Aptech Caswier Ltd

30th September and 13th October 2019

Observations

COLUMN SCHEDULE

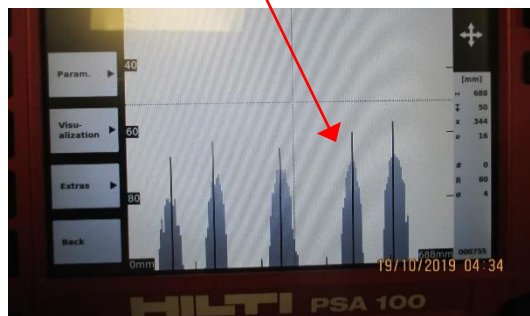
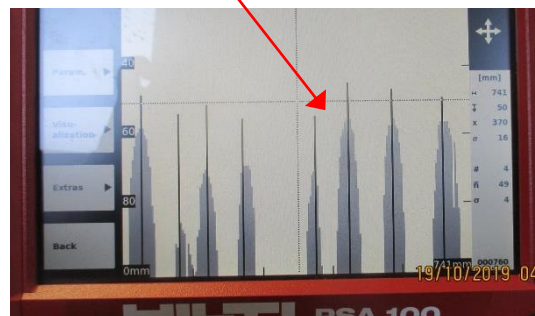
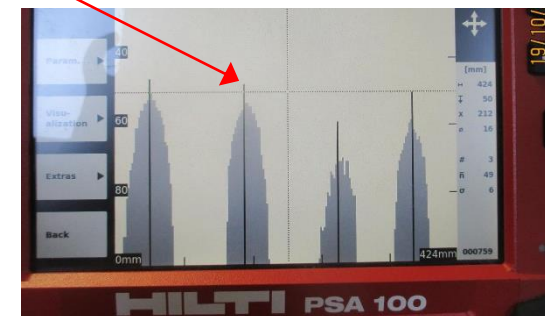
5 rebar were found in long face of C14 column where 6 rebar shows in the column schedule. (14 rebar found instead of 16)

8 rebar were found in long face of C16 column where 10 rebar shows in the column schedule. (18 rebar found instead of 22)

4 rebar were found in both face of C13 column where 5 rebar shows in the column schedule. (12 rebar found instead of 16)

Observation: Suit Building

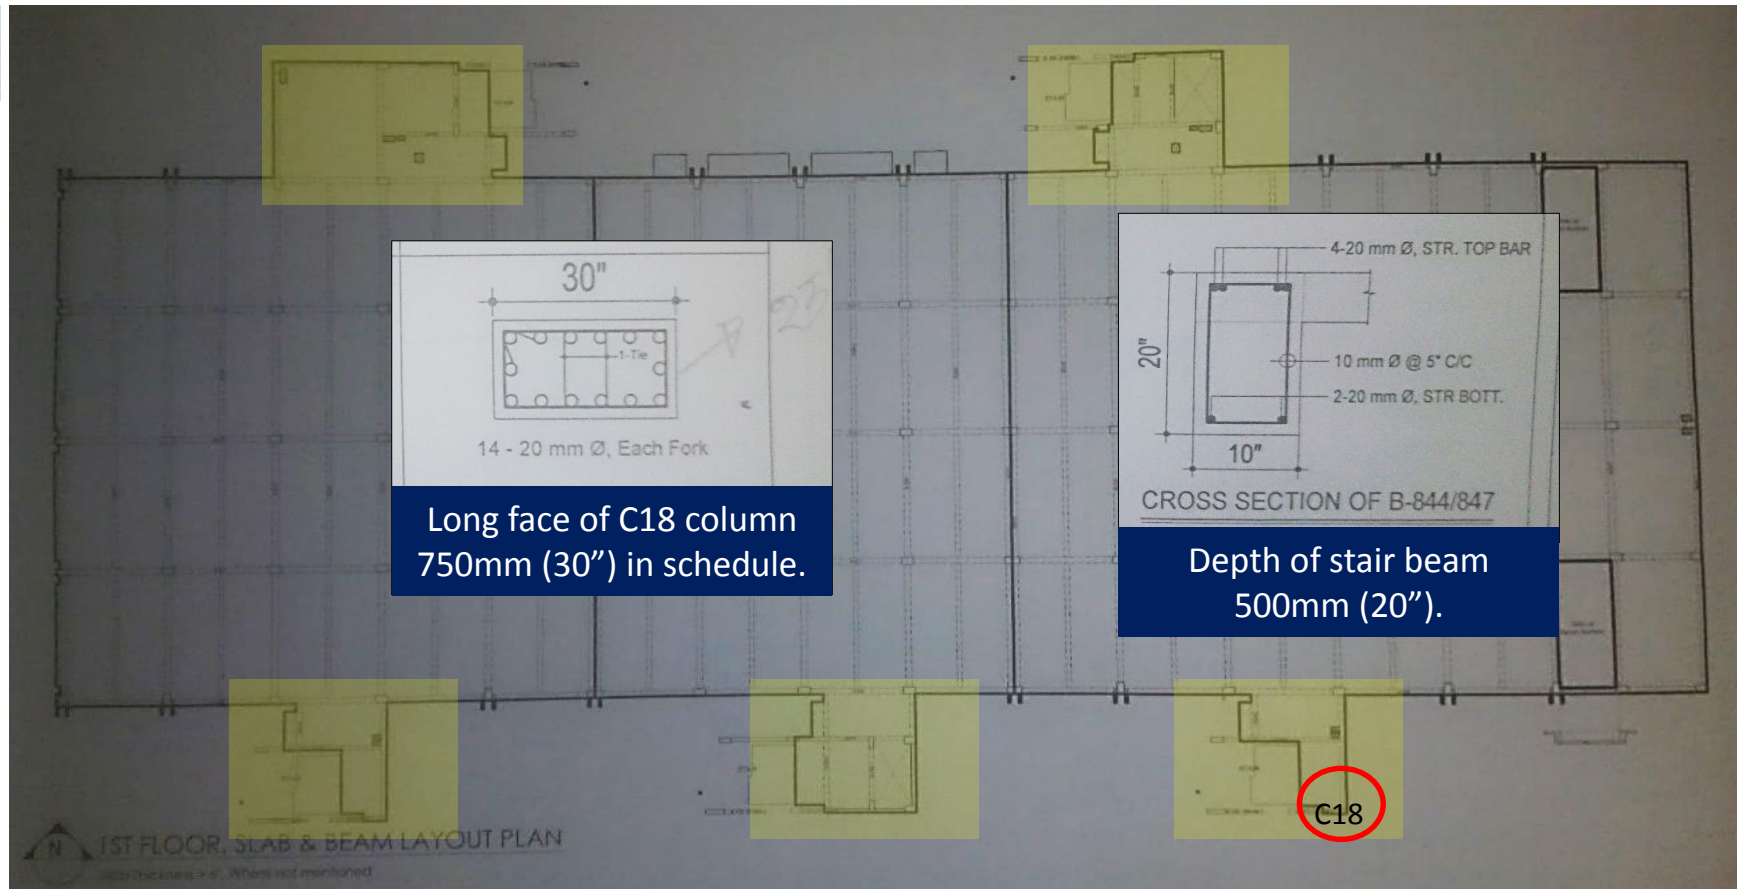
Long face of C18 column
750mm (30") in schedule.

Depth of stair beam
500mm (20").

long face of C18 column was measured 625mm on site where drawings shows 750mm (30"). Also, down stand of the beams in the stair zone was measured 450mm where provided drawings shows 500mm (20") as total depth.

The factory engineer to survey the structure and update the as-built drawings accordingly.

Undocumented Conveyer shed

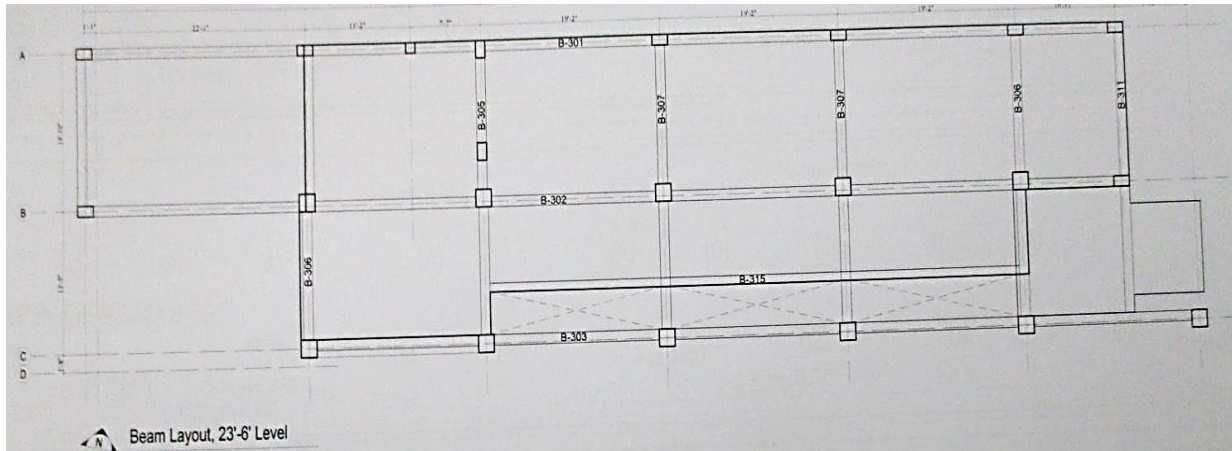
Undocumented lightweight steel conveyer shed was made adjacent to Suit Building. The factory engineer to survey the structure, connections and produce necessary drawings.

Beam layout plan

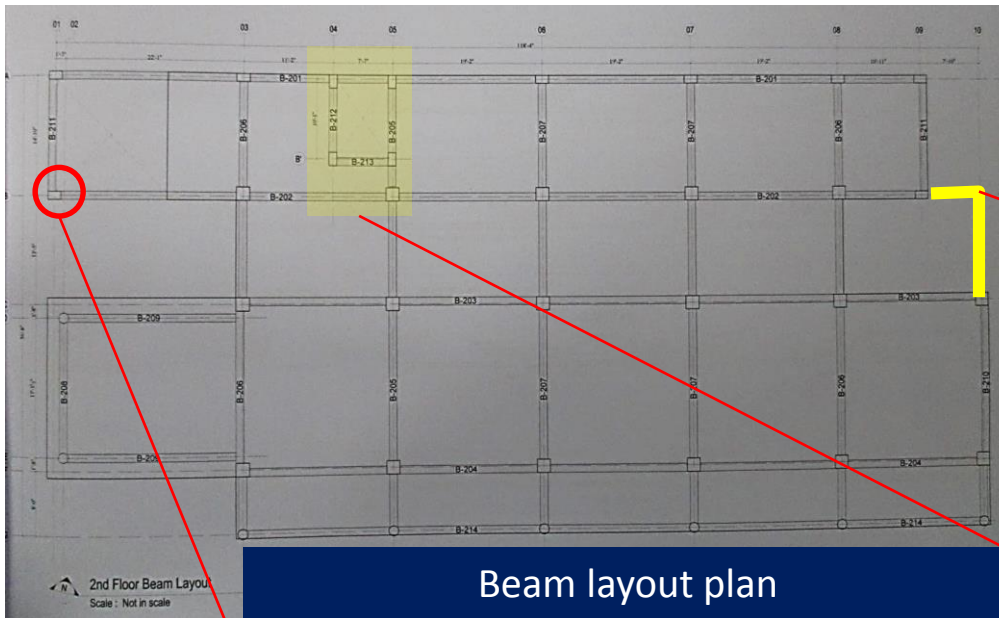
The architectural, structural and floor load plan drawings for the roof level was not available in the provided documents. Beam layout for the roof level was not available in the provided drawings.

Beam at roof level not match with dwg.

Rebar of C6 column in the schedule

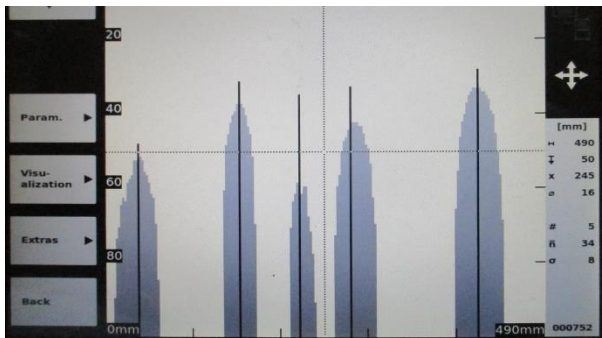
For the C6 column at grid 3-A, Ferro-scanning image shows 5 rebar in long face of where drawing shows 8.

Beam at 2nd floor not match with dwg.
